# VALUE ENGINEERING TRAINING STUDY REPORT

Jodeco Road Interchange - Park and Ride Lot

Project No. CSMSL-0007-00(955)

October 22, 2009

Idea No.: A-3  
Client:  
Sheet of

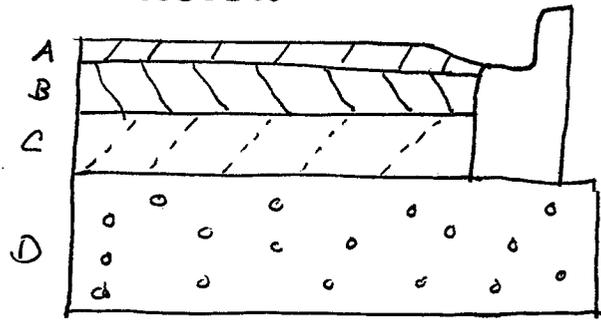
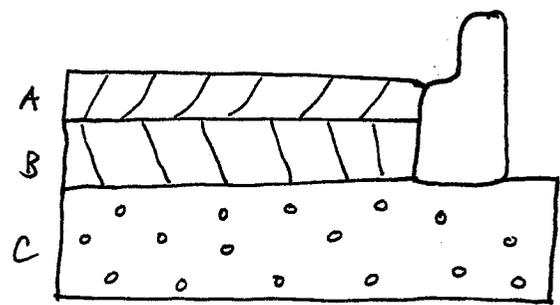
ORIGINAL

A = 135 lb/sy - 9.5mm  
B = 220 lb/sy - 19mm  
C = 330 lb/sy - 25mm  
D = 8" GAB

PROPOSED

A = 4.25" PCCP  
B = 220 lb/sy - 19mm  
C = 8" GAB

The desire is to have same grade as typical section if possible.

Idea No. : 8-6

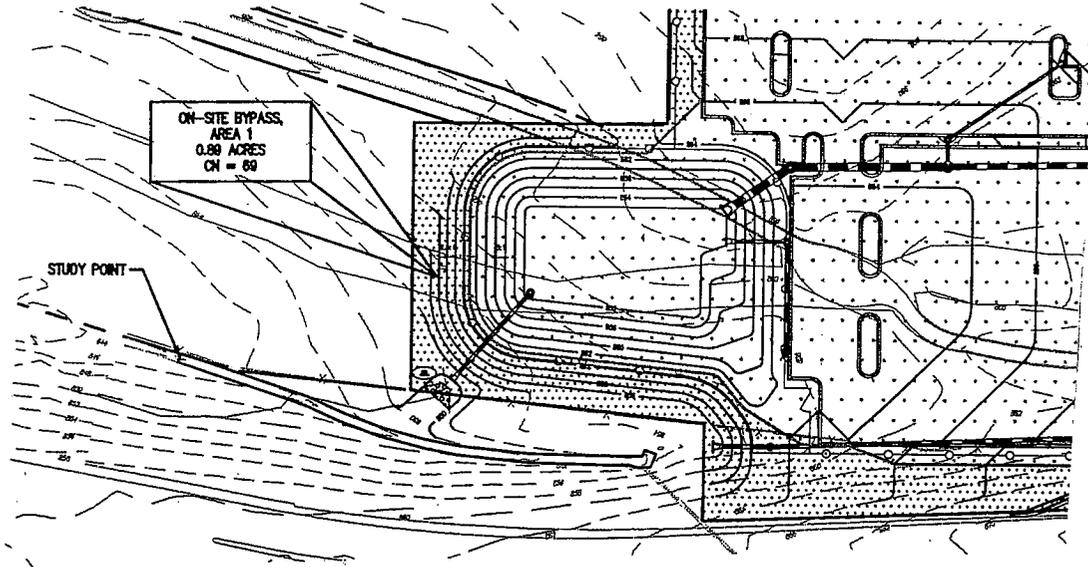
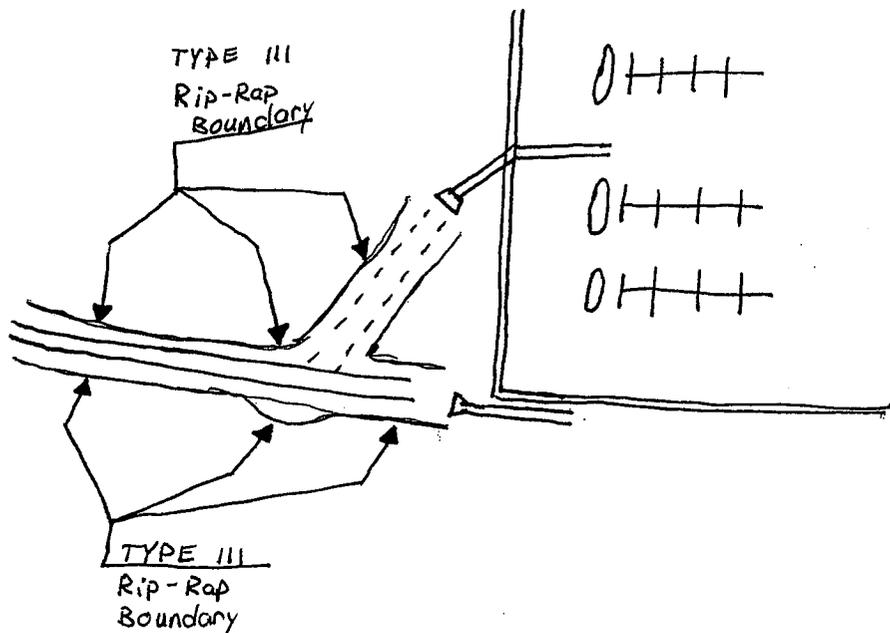
ORIGINAL

PROPOSED

Idea No. : B-6

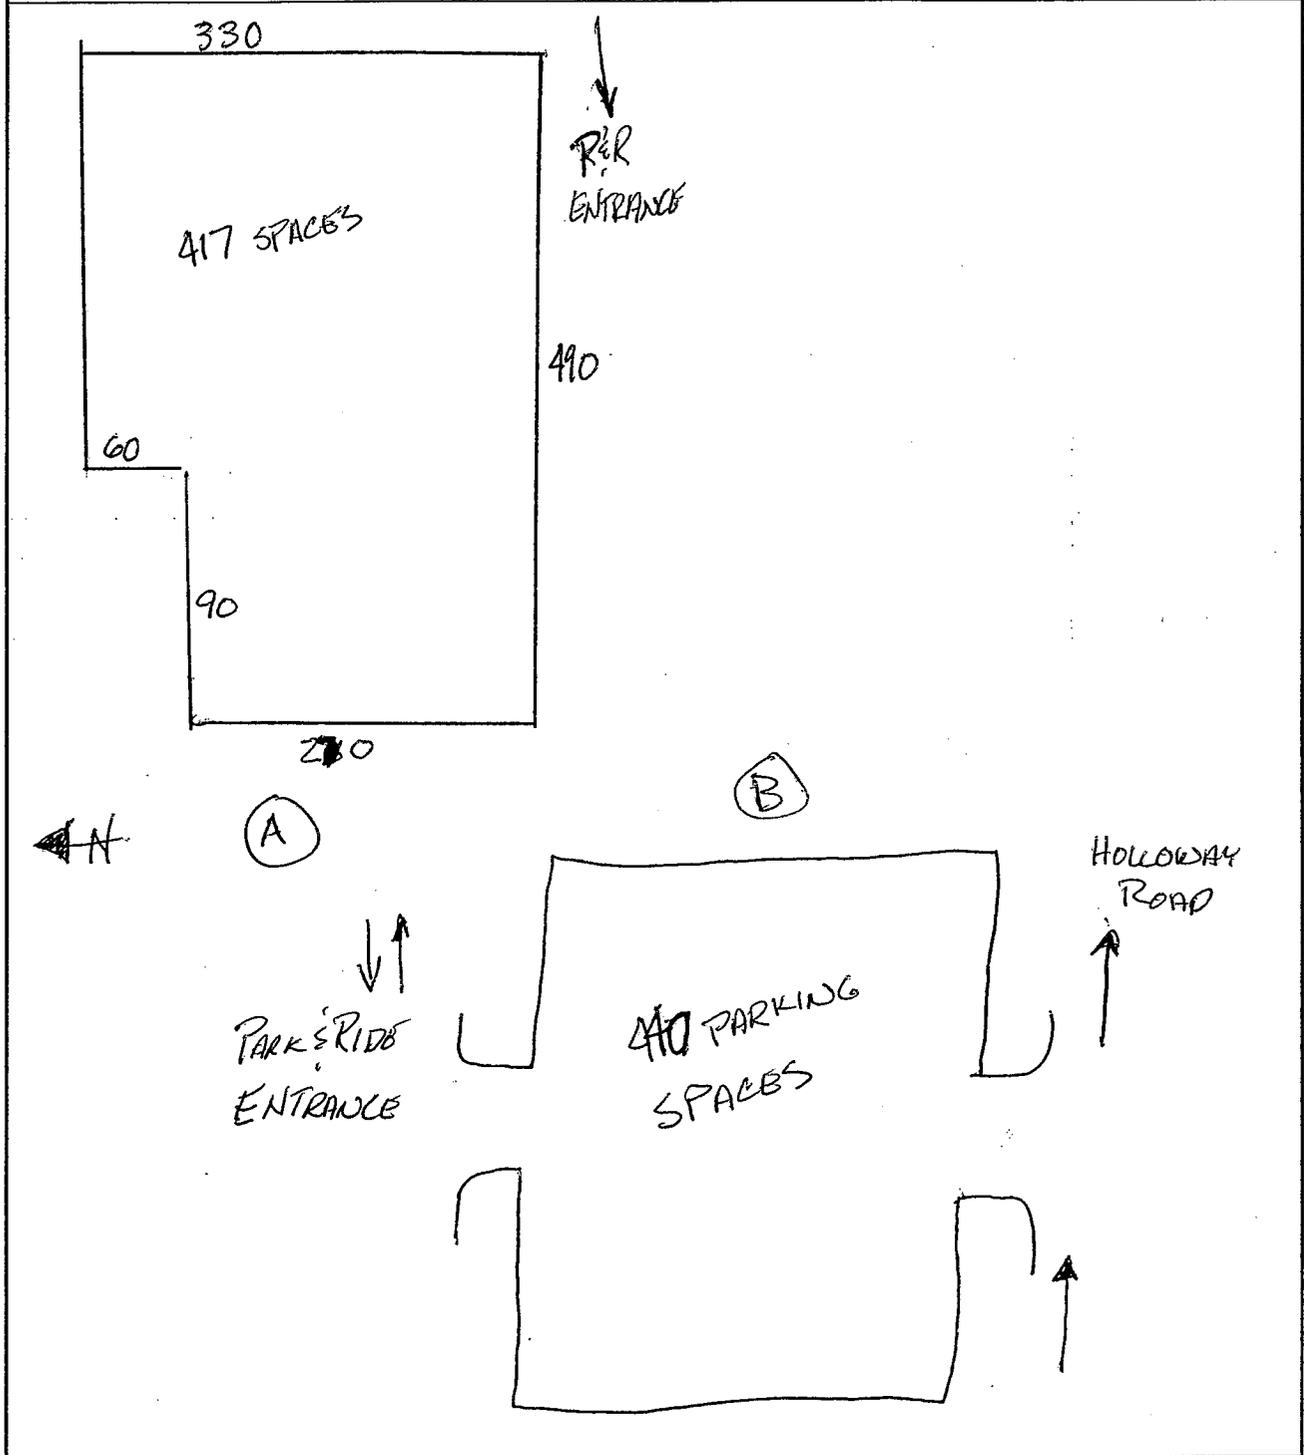
- Retrofit is at pond
- Grading & maintenance of pond = \$40,000
- Rip Rap area = 6' x 550'  $\approx$  375 yd<sup>2</sup>
- 1 gate at pond
- 100' less fence
- Only changed 24" pipe (reduced it by 67')
- Class B concrete flume is 48 yd<sup>3</sup>, not 98 yd<sup>3</sup>

Idea No.: C-3

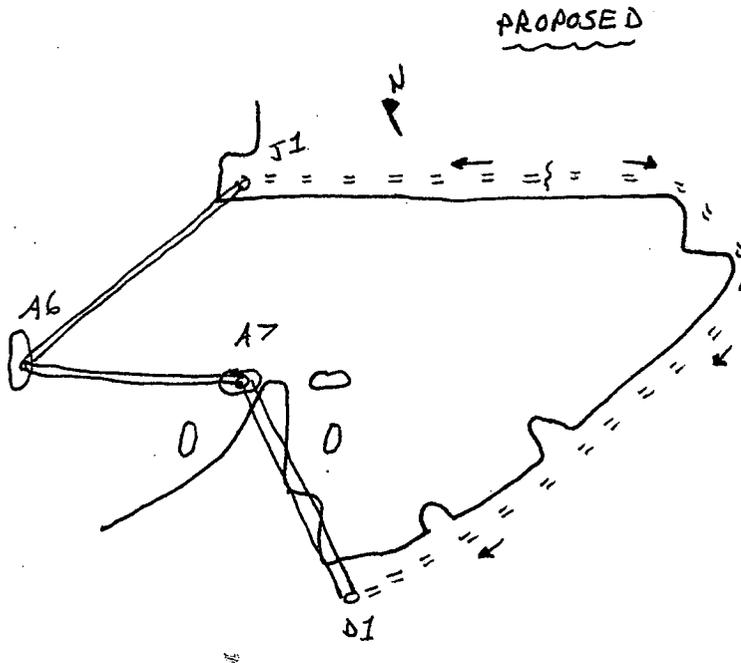
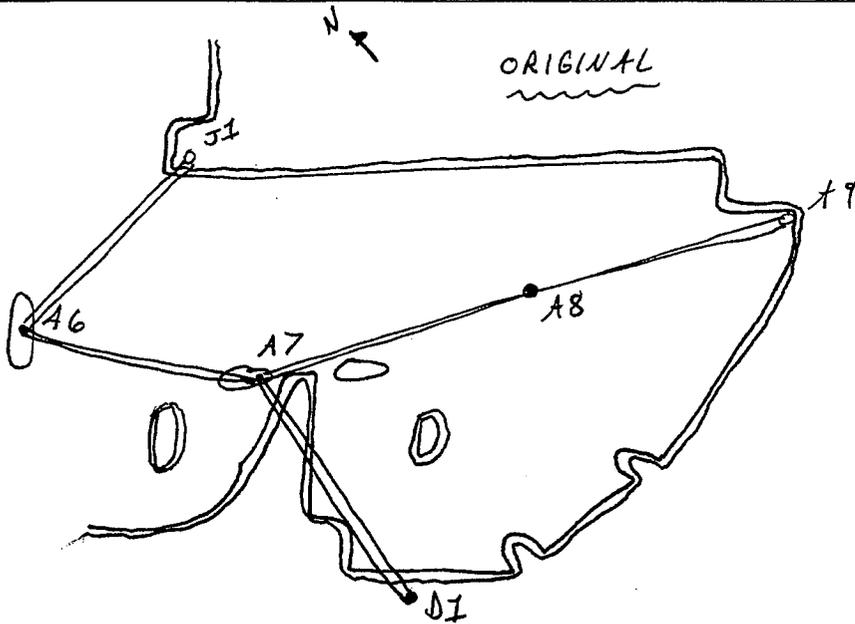
Eliminate  
 A9, A8  
 A9 → A8, A8 → A7  
 c & g from J1 → D1

~~Add~~ Modify  
 J1 structure to  
 Drop Inlet

Idea No.: D4/E1

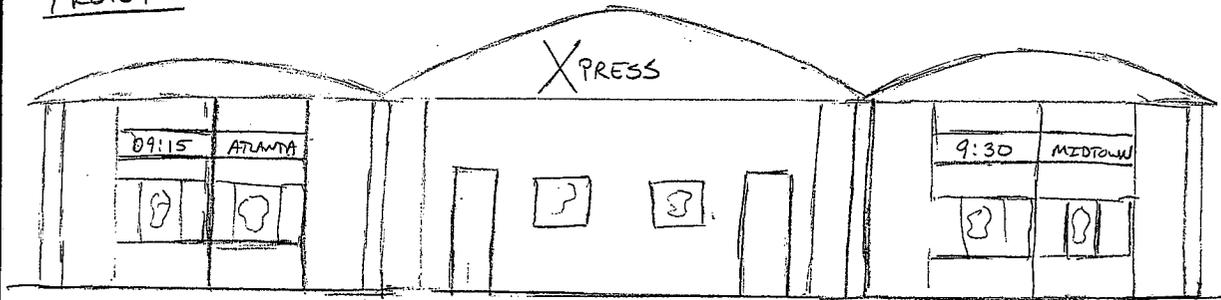
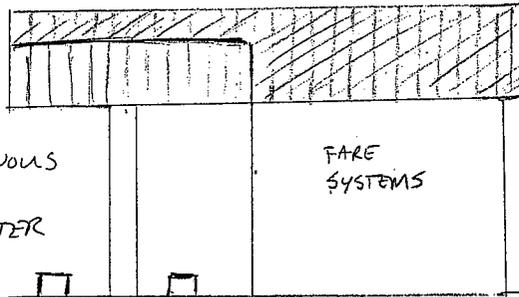
CONTINUOUS  
BUS  
SHELTER

FARE  
SYSTEMS

Idea No. : M-1  
Client::  
Sheet of

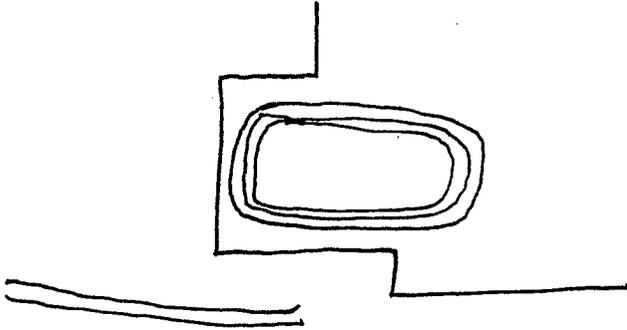
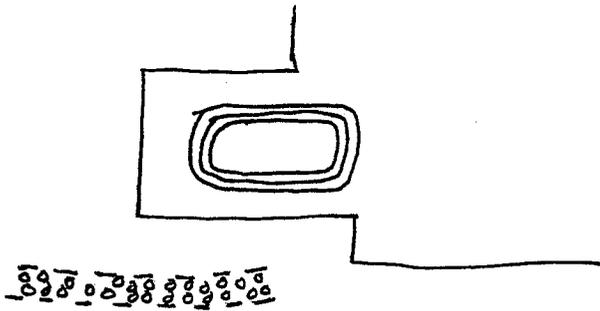
Original Concept: *Install concrete flume with Class B concrete near retention pond.*

Proposed Change: *Construct ditch & line with rip rap.*

Justification: *Better erosion control.  
More environmental sensitivity.  
Enhanced aesthetics.  
Increased velocity dissipation.  
Increased seepage into ground.*
